SECTION 905 -- PROPOSAL (CONTINUED)

| Number | Description |
|--------|---|
| 1 | Revise Table of Contents, replace same; Add NTB Nos 4658, & 4662; Revise Bid Items, replace same; Add or Revise Plan Sheet Nos. 2-3, 5, 8, 11-12, 14, 19, 28, 53, 55, 87, 8001-8004, 8006, 8008-8009, 8011-8013, 8017, 8019, 8027, 8029-8030, 8032, 8034-8037, 8042, 8048-8051, 8053, 8055-8056, 8062, 8068; Amendment EBS Download Required. |

BR-0019-02(041) / 105189301

Bridge Replacements on SR 7 at Bridge Nos. 154.0, 154.8, 155.0, known as Federal Aid Project No. BR-0019-02(041) / 105189301 in Marshall County.

MISSISSIPPI DEPARTMENT OF TRANSPORTATION
BRIDGE AT STA. 229+81.21
INTERMEDIATE BENT NO. 9
PROJECT BR-0019-02(041)
MARSHALL COUNTY AIO OF 24
WORKING NUMBER 8013
SHEET NUMBER

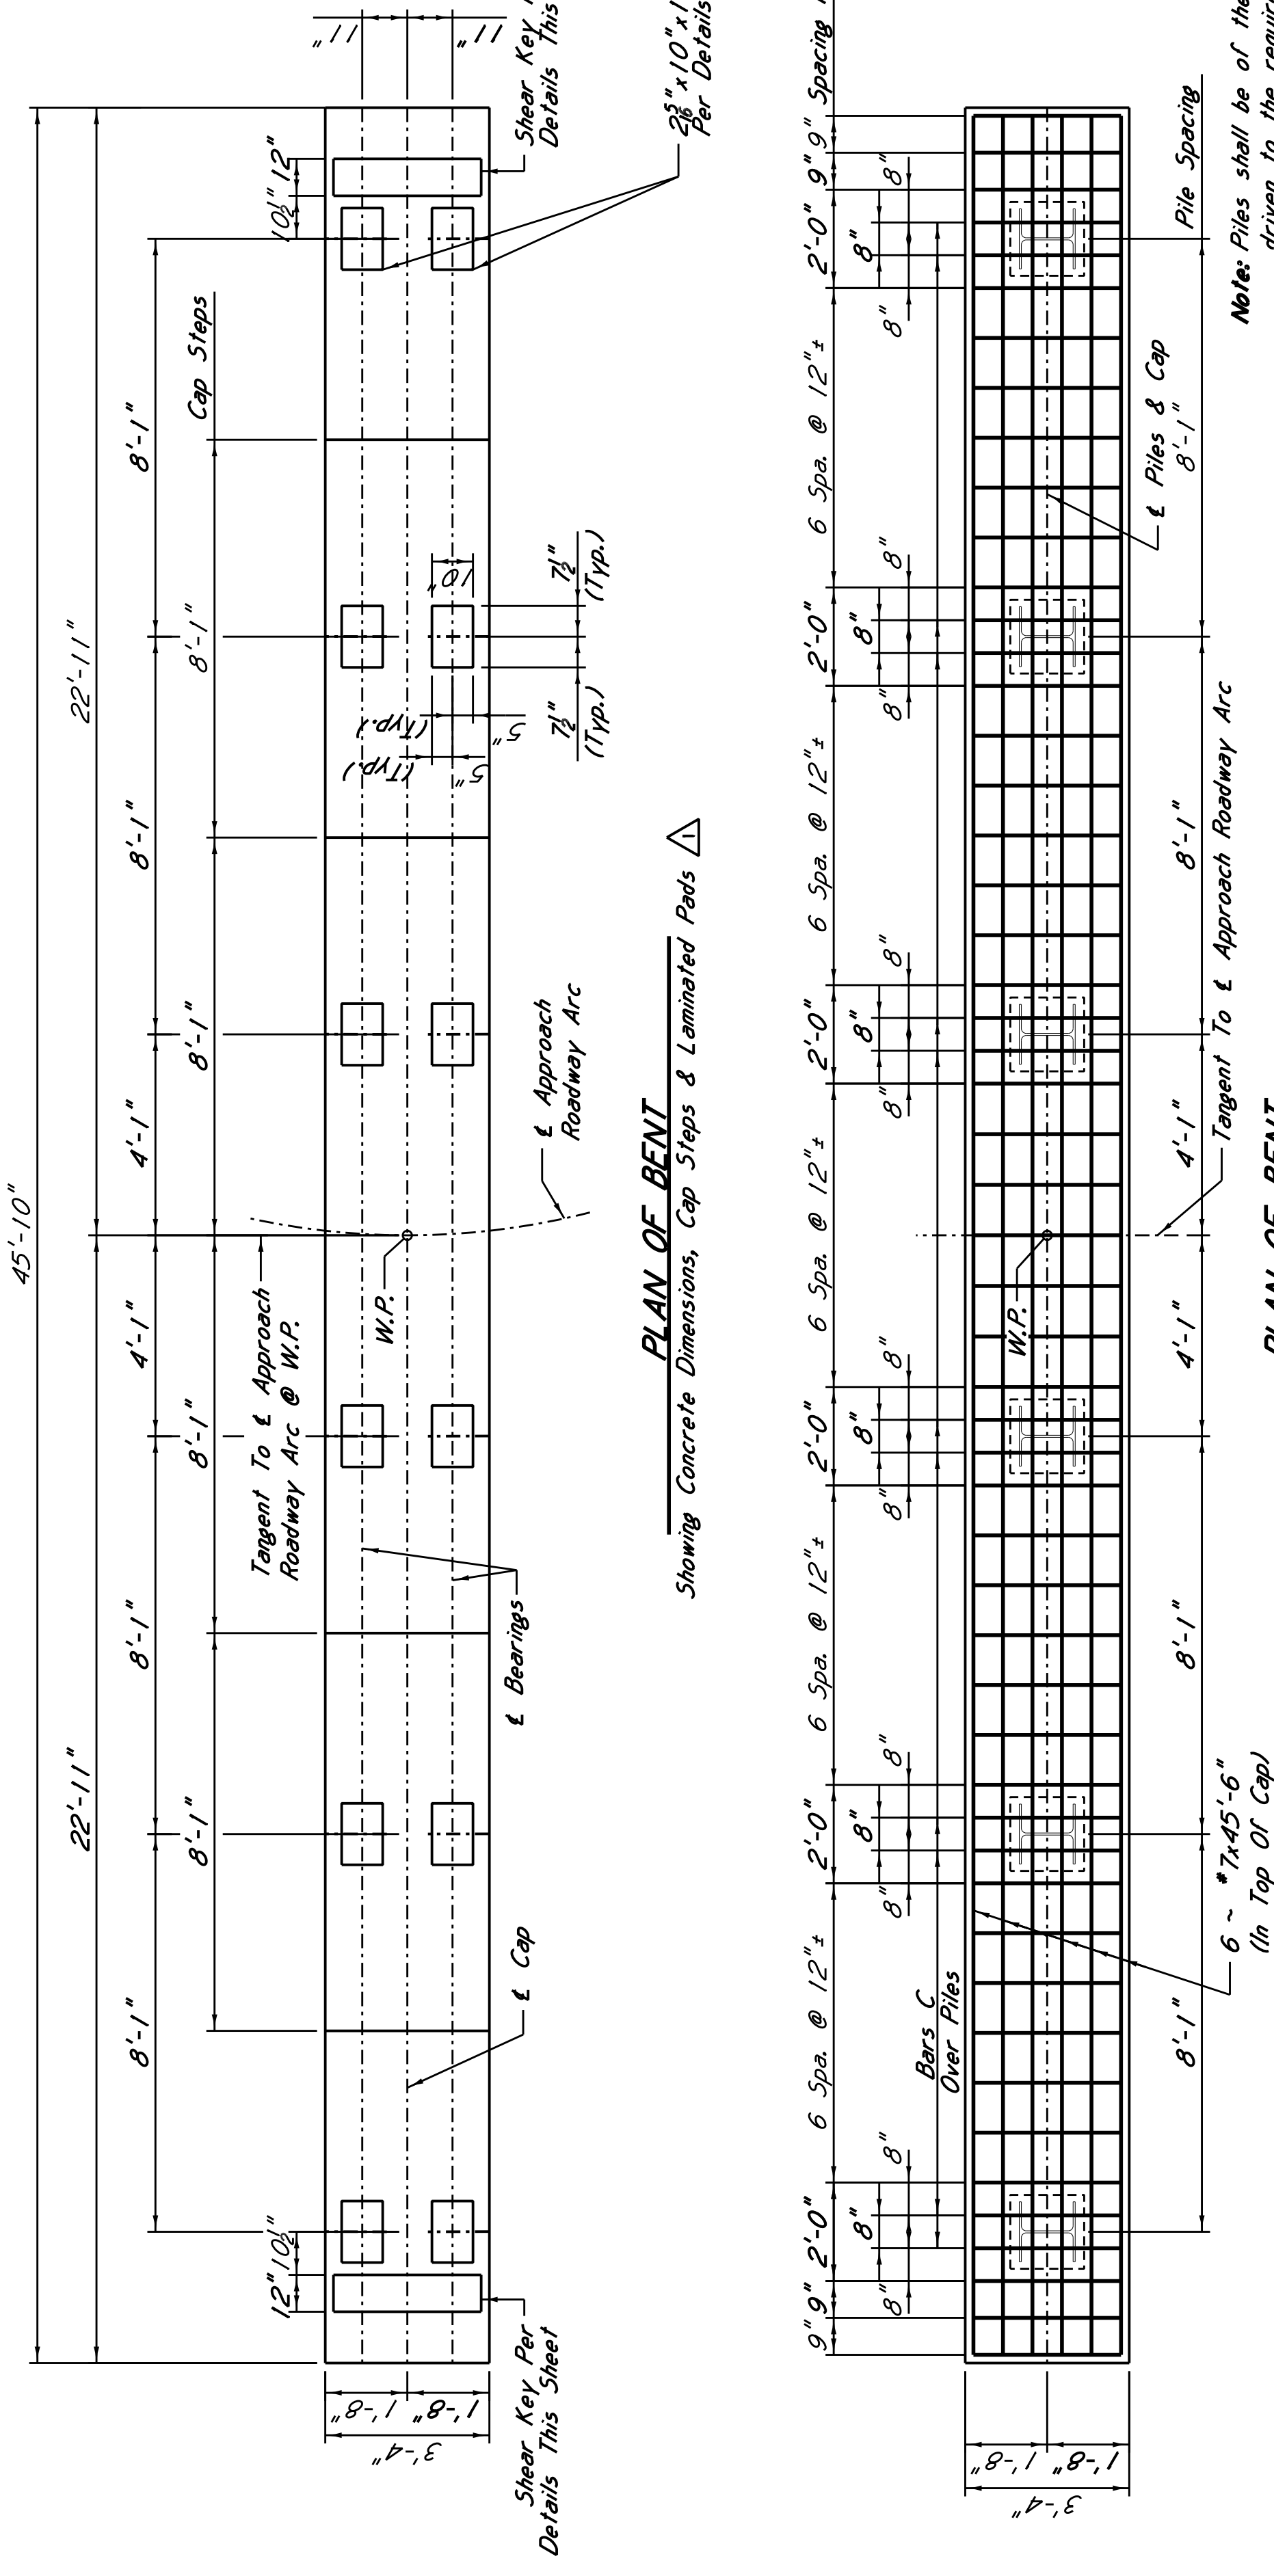
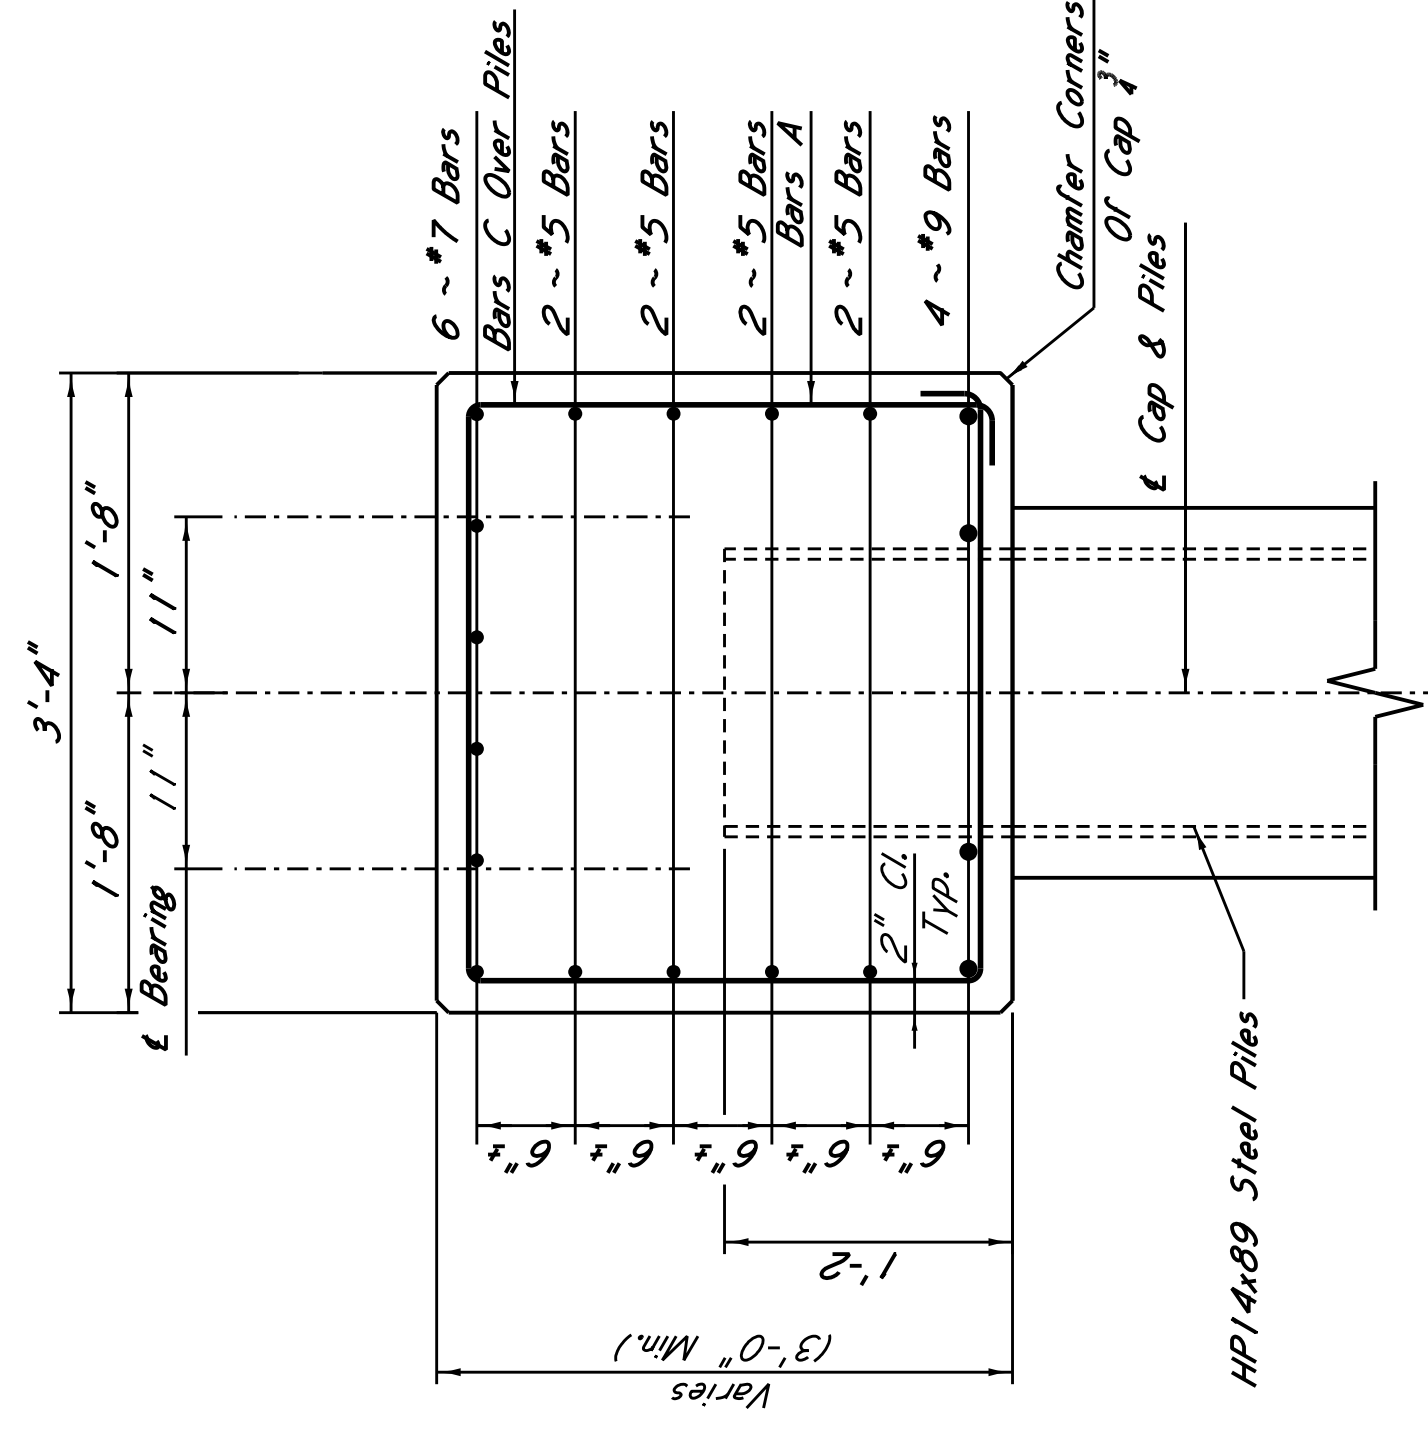
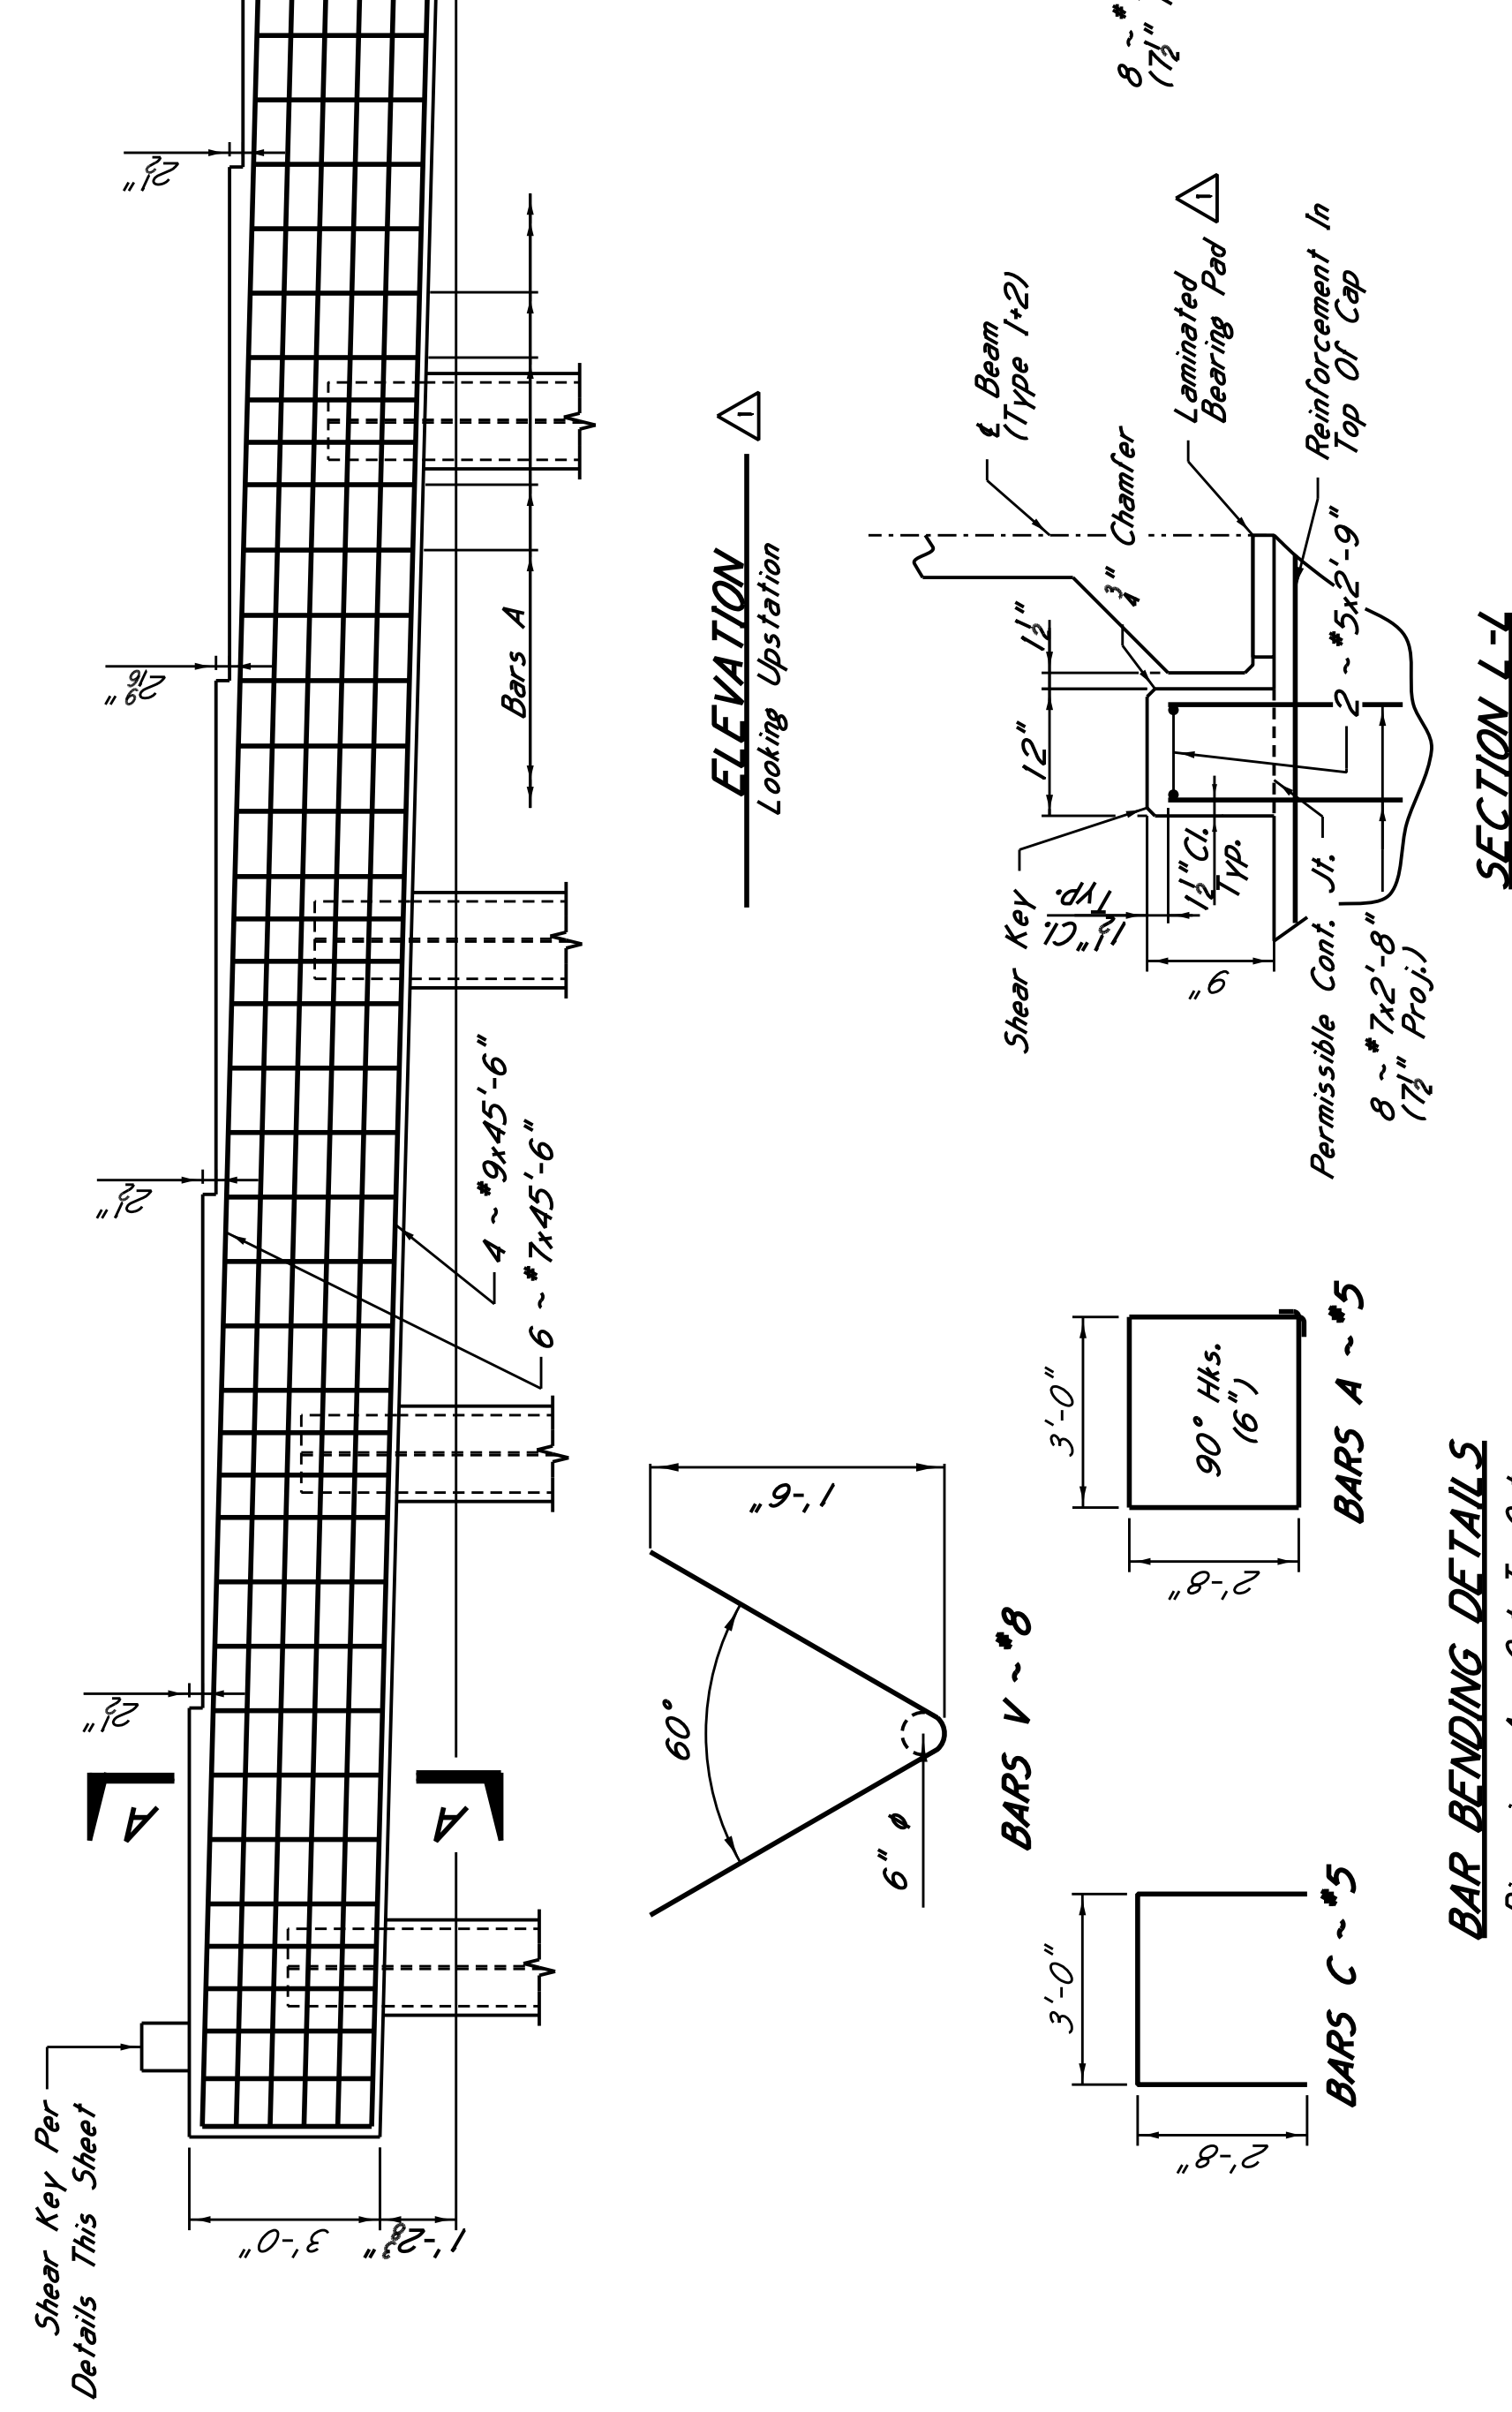
| REVISIONS | | | |
|-----------|------|----|--------------------------|
| 1 | | | Reference & note revised |
